SUBMISSION OF DETAILS TO COMPLY WITH CONDITIONS

**LAND SOUTH OF WOKINGHAM, EAST OF FINCHAMPSTEAD ROAD AND WEST OF WATERLOO ROAD,
WOKINGHAM**

**PLANNING PERMISSION 192928 (CONSTRUCTION OF THE SOUTH WOKINGHAM DISTRIBUTOR ROAD (SWDR)
BETWEEN FINCHAMPSTEAD ROAD AND WATERLOO ROAD, INCLUDING A LINK TO HEATHLANDS ROAD,
TOGETHER WITH ASSOCIATED WORKS)**

CONDITIONS REFERENCES: 213417, 213430, 213441, 213554 & 213995

Condition 5 levels (213441)

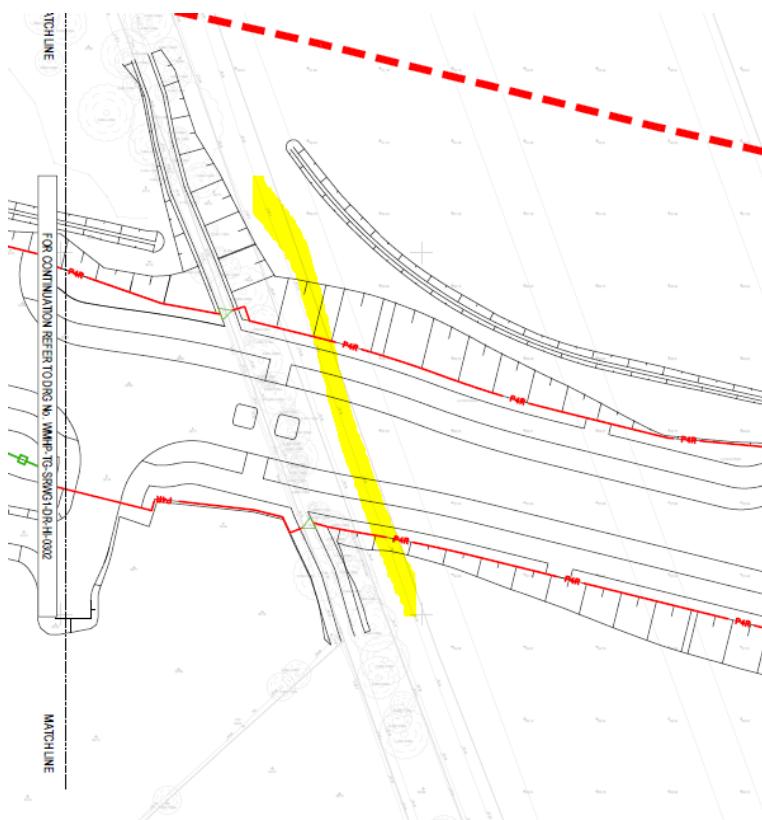
Please provide chainage drawings and longitudinal sections, as provided at the original application stage, showing existing, approved and proposed levels to allow comparison. I am aware that the consortium have raised concerns about the level of the road being increased and need to understand the scope of the issue.

and on WMHP-TG-SRWG1-DR-HI-301:

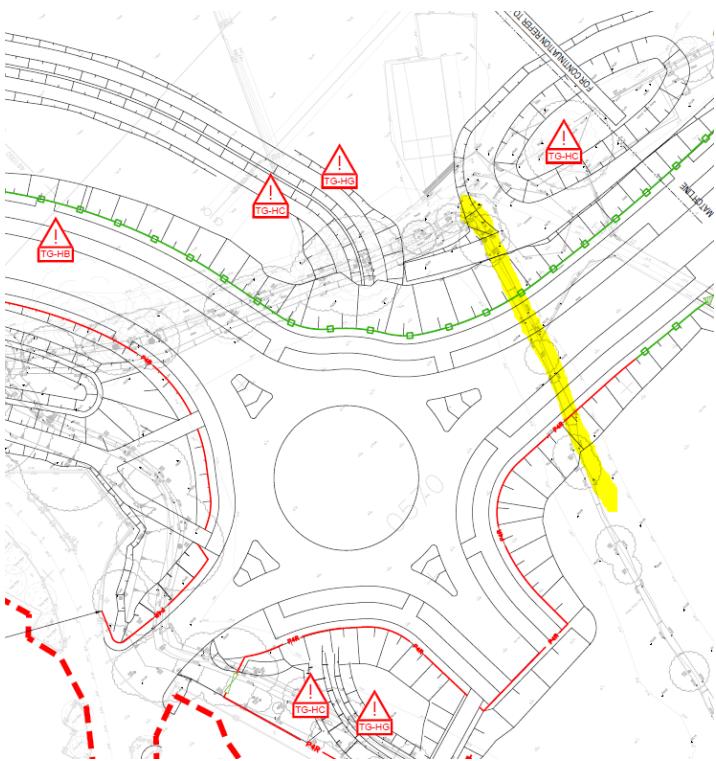
Additional mammal tunnels are required in these two locations, with reference to the fencing plans, on WMHP-TG-SRWG1-DR-HI-0303 (highlighted yellow):

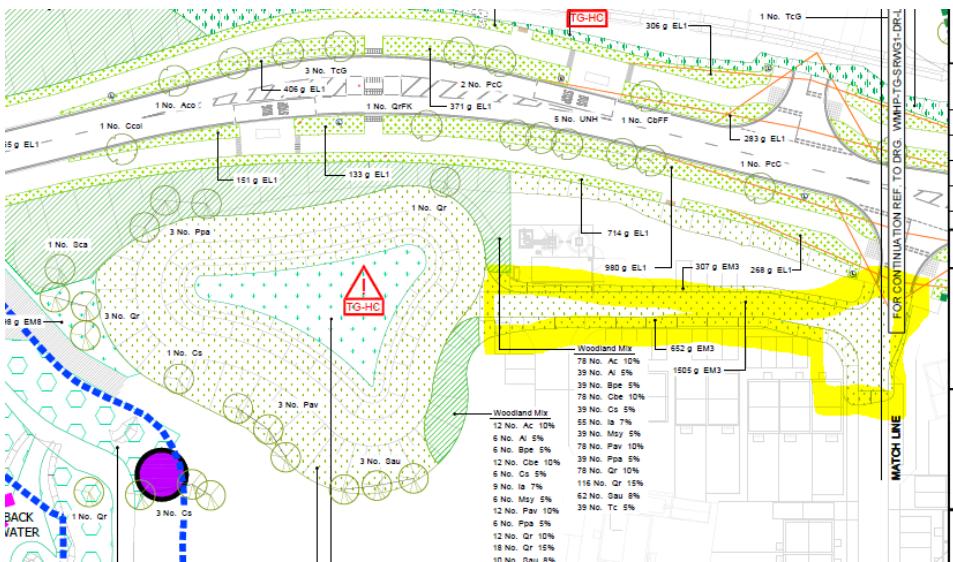
With regard to enclosure:

- A detail is needed showing how the wildlife mesh fencing will attach to the bridge over the Emm Brook, to ensure that there is a secure junction (yellow dots).

- Other than the balustrading over the footbridge, the fencing from either side of footpaths 9 & 24 should be removed (purple line)
- Fencing with wildlife mesh should be continued into the SANG on the eastern side of the footpath (blue line)

- The fence-line should be continued along the back of the highway and a less intrusive gate (eg a sturdy five bar gate with wildlife mesh) at the SuDS maintenance access (turquoise line)

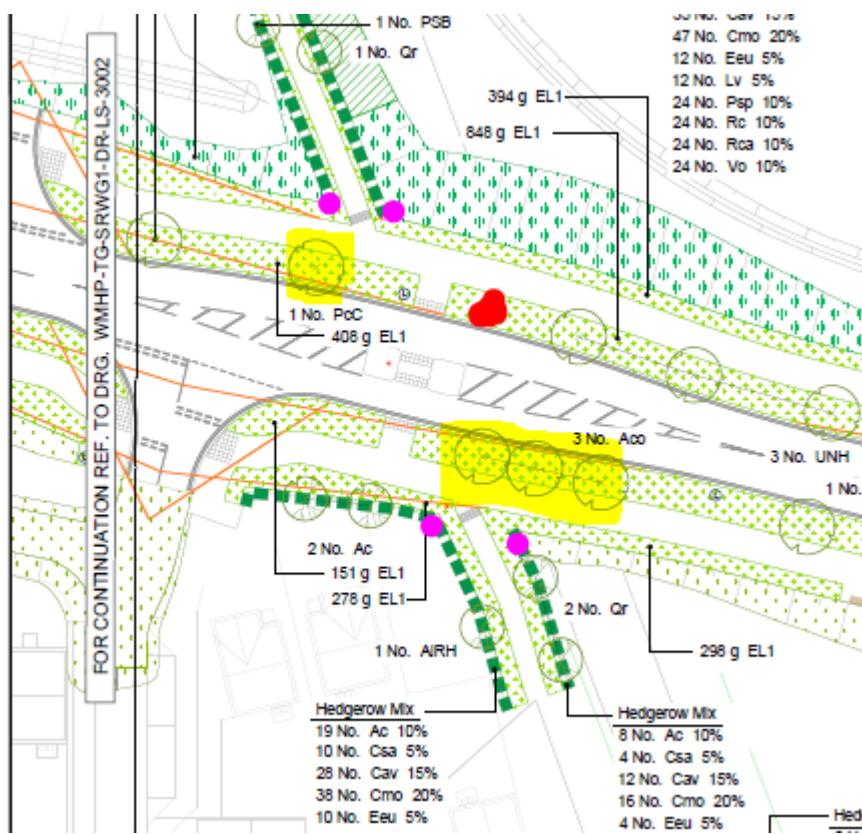
3003 P04 – The SWDR bisects an existing footpath with hedgerows that is a bat commuting corridor. As a lighting column has to be here for the pedestrian island it is important to mitigate the lighting disturbance through the tree planting. The specified *Alnus cordata* and *Pyrus calleryana* 'Chanticleer' will not create a dark hop over route for bats using this route. The *Quercus*, *Tilia*, or *Ulmus* species used in the street tree palette would be more appropriate for the trees highlighted in yellow below and an addition street tree should be provided in the location indicated in red below. The replacement hedgerow planting should terminate in a *Quercus*, *Tilia*, or *Ulmus* species standard (in the locations shown by pink dots) to further reinforce a safer at height flight route.
